Submission to National Transport Authority

**Bray to City Centre BusConnects Scheme
(ABP Reg. Ref. HA27.317742)**

Client:	Sir Marc Cochrane
Project Title:	BusConnects Bray to City Centre Route
Document Title:	BusConnects Submission – Woodbrook Estate
Document/Job	JSA 19089 Ref 10102023 DV4

Figure 3.1: Extract from General Arrangement Sheet 49 (Source: NTA, 2023) with redline illustrating Woodbrook Estate.

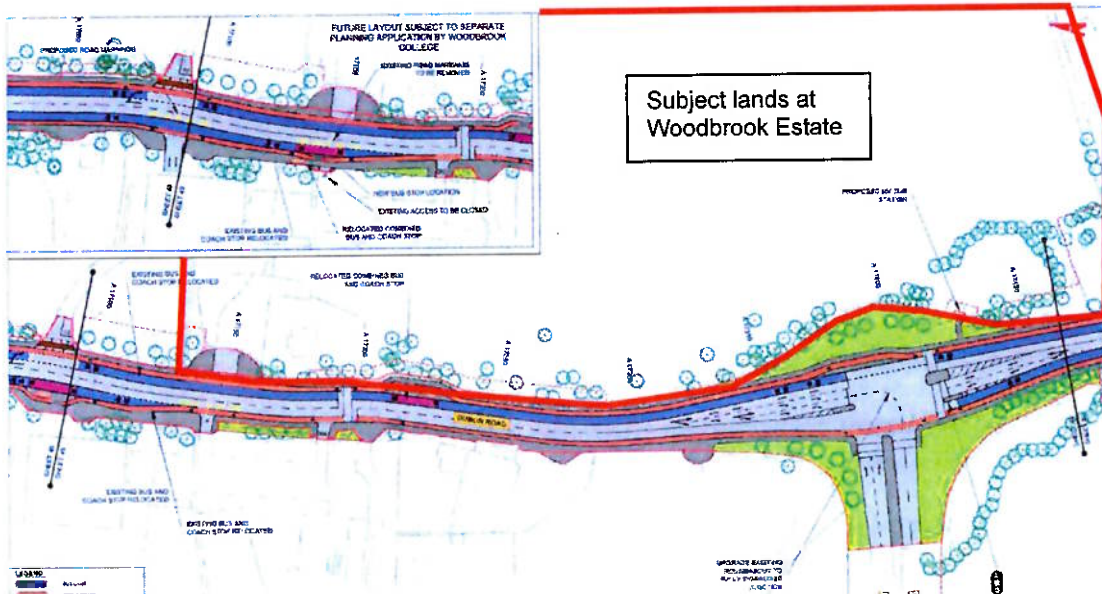
- 3.2. Extracts of the 'General Arrangement Drawings' Sheets 49-50 (Figure 1 and 2 below) set out high level details of the route proximate to the Woodbrook Estate.

- 3.5. Enclosed landscaping drawings details sets out trees proposed to be removed along the boundary with the Woodbrook Estate primarily on the eastern side of the Dublin Road. Annotation on the drawing states that existing wall, trees and vegetation up to 4m from the wall to be removed. The wall is to be set back and re-built.

- 3.6. The alignment through this section entails significant tree loss along the frontage with Woodbrook Estate back. Replacement native planting is proposed to re-establish the vegetation belt along this side however the nature and extent of this planting is not clear. The existing wall is to be demolished and set back proposed wall reinstatement north of the M11 diverge junction will be detailed to match the stone material seen elsewhere along this section.

Figure 3.2: Extract from General Arrangement Sheet 50 (Source: NTA, 2023) with redline illustrating Woodbrook Estate.

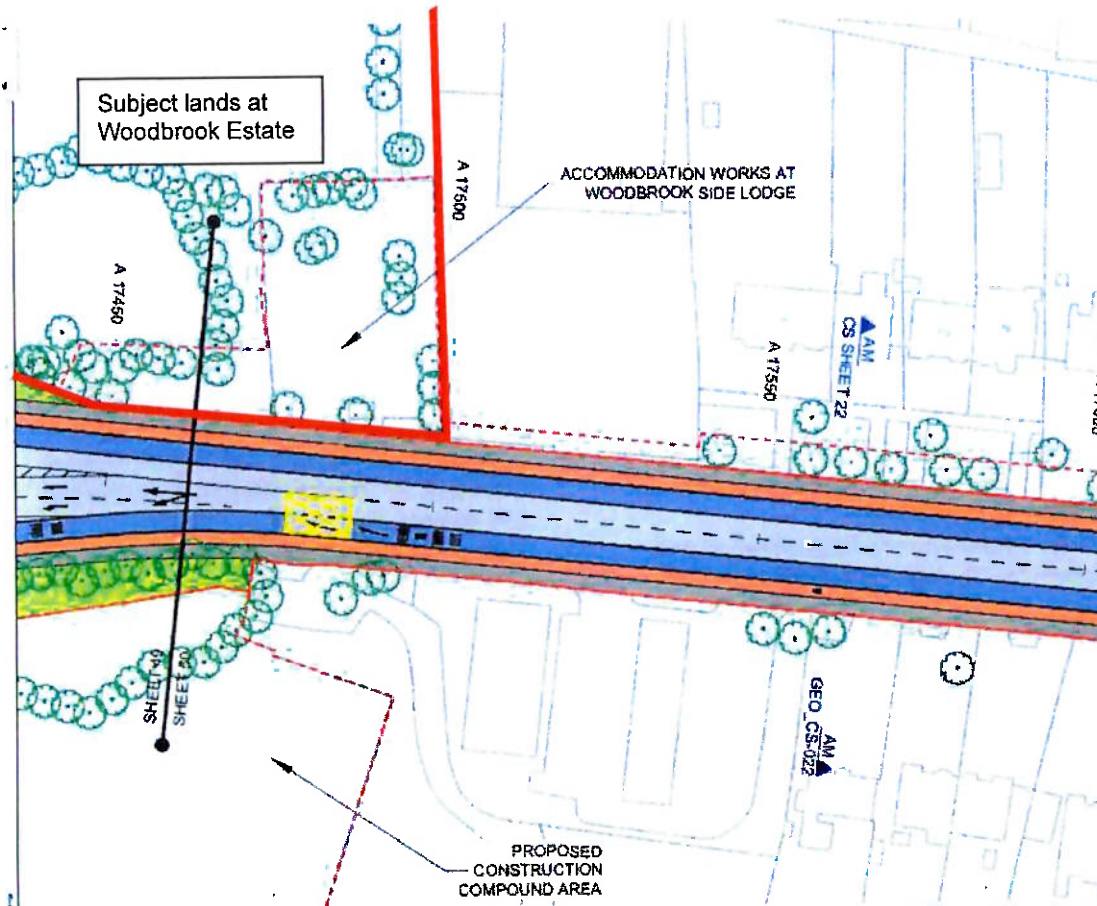
- 3.7. The drawing also notes: *'Stone setts and wide granite kerbs to enhance historic gated entrance into Woodbrook estate.'*
- 3.8. Figures 3.3 and 3.4 below illustrate the extent of landscaping proposals and the consequent loss of trees proposed.

Figure 5.4: Extract from '20.-Woodbrook-Side-Lodge-General-Arrangement-1' (Source: NTA, 2023).

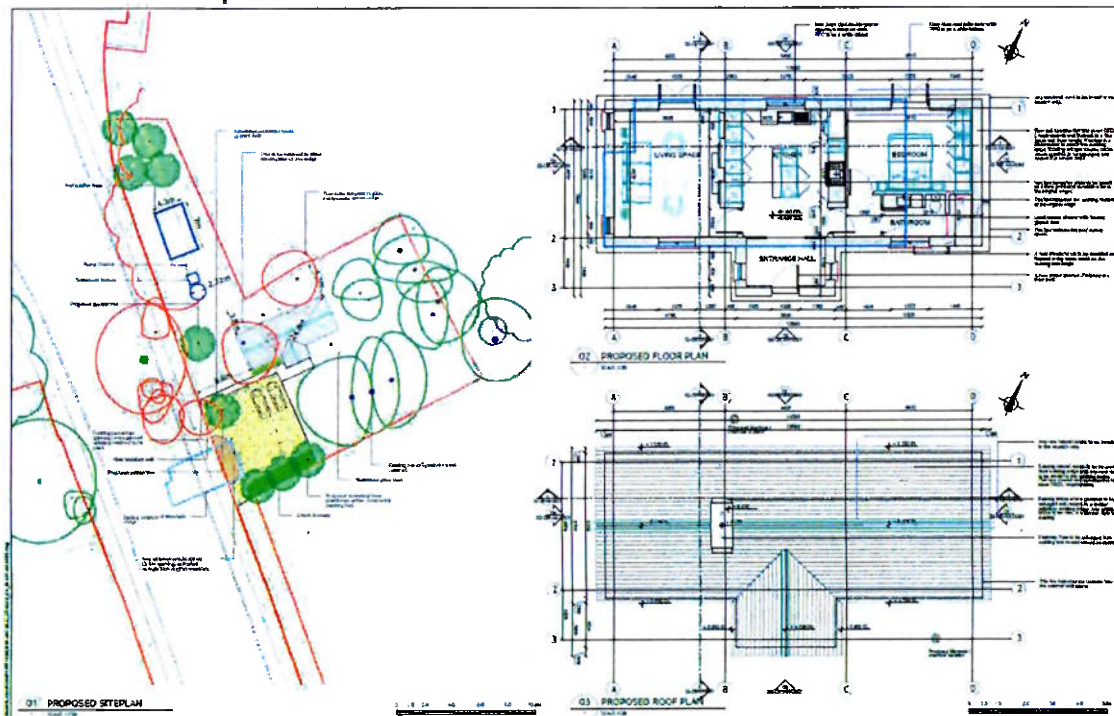
- 5.11. The proposal notes that the historic gated entrance into the Woodbrook Estate remains unaffected by any carriageway widening. The landscape drawing notes: *'Stone setts and wide granite kerbs to enhance historic gated entrance into Woodbrook estate'* are proposed which are considered a positive intervention.

- 5.14. We note the provisions of Section 57(10)(b) of the Planning and Development Act (as amended) which states:
- "A planning authority, or the Board on appeal, shall not grant permission for the demolition of a protected structure or proposed protected structure, save in exceptional circumstances."*

- 8.9. We request that ABP request that the Applicant provide revised drawings of the proposal as detailed in this submission, and in particular, an alternative layout which significantly reduces the impact on the historic and sensitive landscape of the Woodbrook area, retaining the Woodbrook Side Lodge, a protected structure.

Fig. 2 – Northern section of Estate frontage

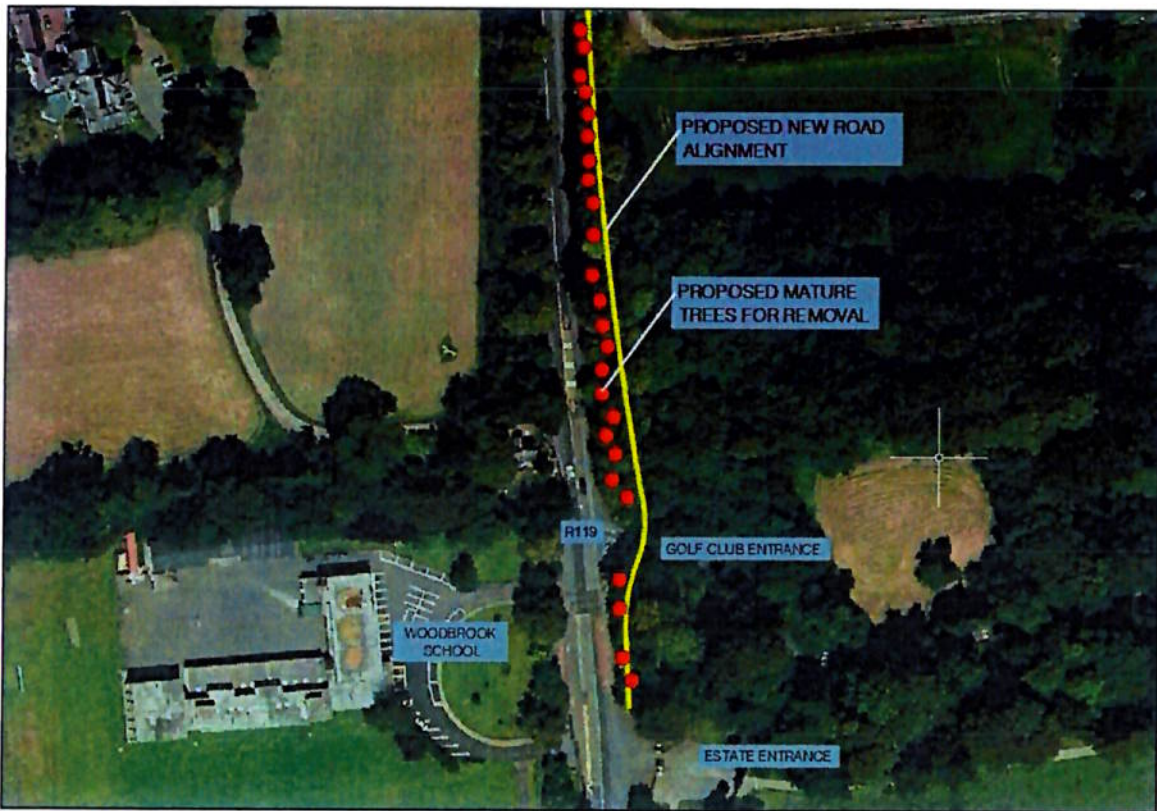
The northern section of the estate frontage includes a narrow group of trees with open fields to the rear and a section with dense mature woodland. The trees are mainly mature Chestnut (*Aesculus hippocastaneum*) up to 20M in height and with several mature Beech (*Fagus sylvatica*) also up to 20M in height. All the trees are within 5M of the boundary wall. There is also of a stone lined feature which runs at right angles to the boundary wall and there is a height differential between one side and the other.

The removal of the tree line adjoining the field would leave a significant gap in the roadside tree line which would greatly alter the environment and visual amenity of the roadside planting. The removal of trees at the western edge of the woodland would put the remaining adjoining trees at risk of wind damage.

Fig. 3 – Entrance gates & gate lodge

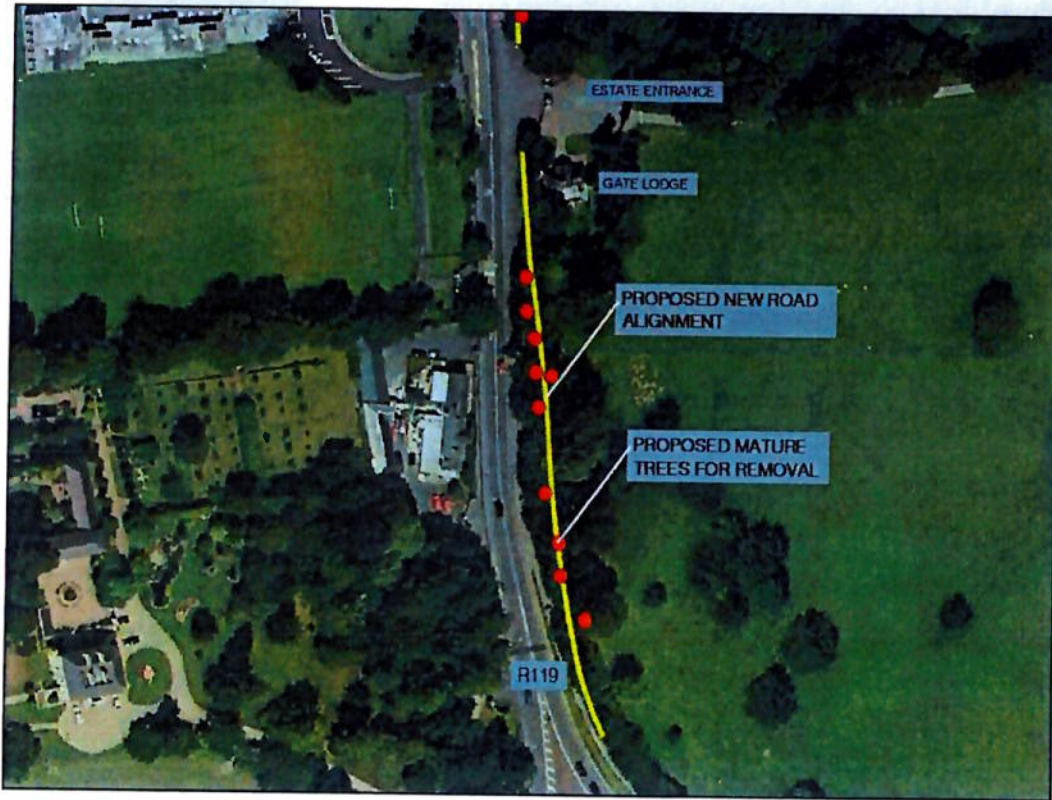
The middle section of the Estate frontage includes the listed entrance gates and listed gate lodge. While the widening proposals will retain the entrance gates and gate lodge the trees on either side of the gateway would be removed which would create a significant visual impact on the setting of the gates and gate lodge.

The proposed works in this area would remove the majority of the mature trees exposing the estate to adjoining properties and impacting on views from the house and grounds.

Fig. 4 – Roundabout & southern section

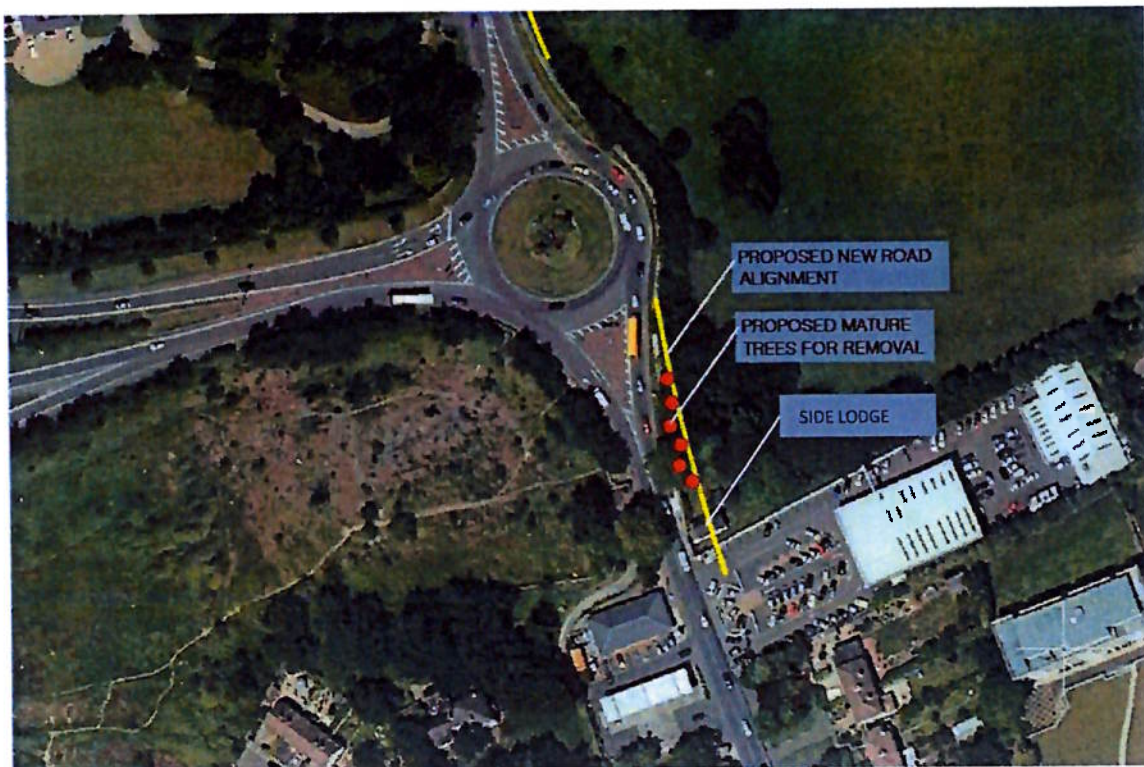
grounds from traffic entering and existing the M11. The BusConnects proposals will result in the removal of a significant number of mature woodland trees from the corner of the site. The creation of manageable slopes would also result in more trees being removed.

Figure 2 – Annotated Extract NTA GA Drawing #48 of 54

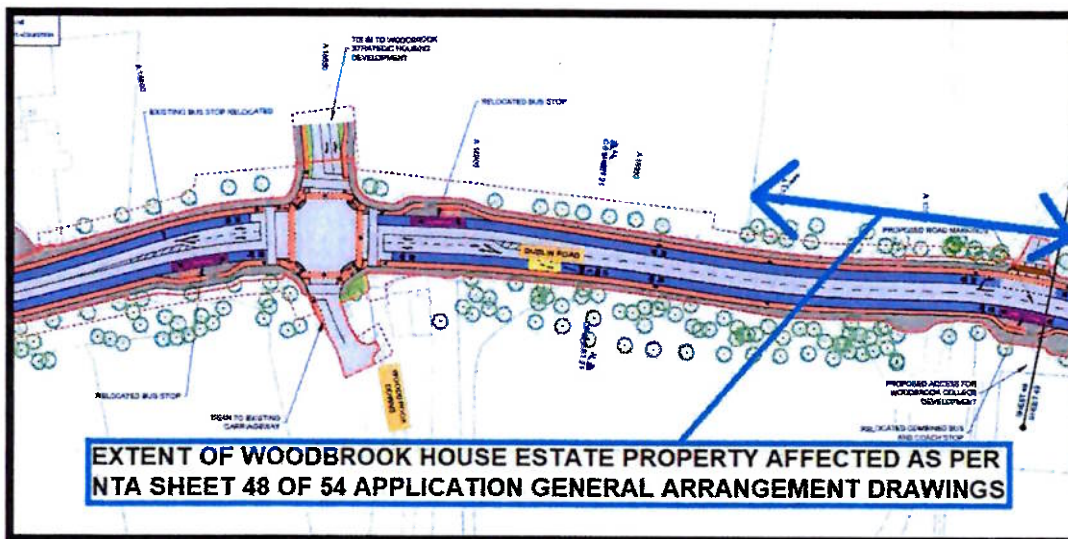
We use annotated extracts from the NTA General Arrangement Drawings (Sheet #48 and #49) below to identify the clients lands affected by the Bus Connects Plans, below as **Figure 2** and **Figure 3**.

As previously proposed, we believe that the appropriate and far less damaging / contentious option for the Bray / City Centre section of Core Corridor 13 here would be to utilise a shared cycle & bus lane on both sides at this area, **similar to other sections of the Planned route e.g., in Donnybrook**. Unlike the offline cycle lane option proposed at Shankill, which is less direct and longer and therefore less attractive to cyclists, this provides a direct route to cyclists while reducing the impact on Woodbrook Estate.
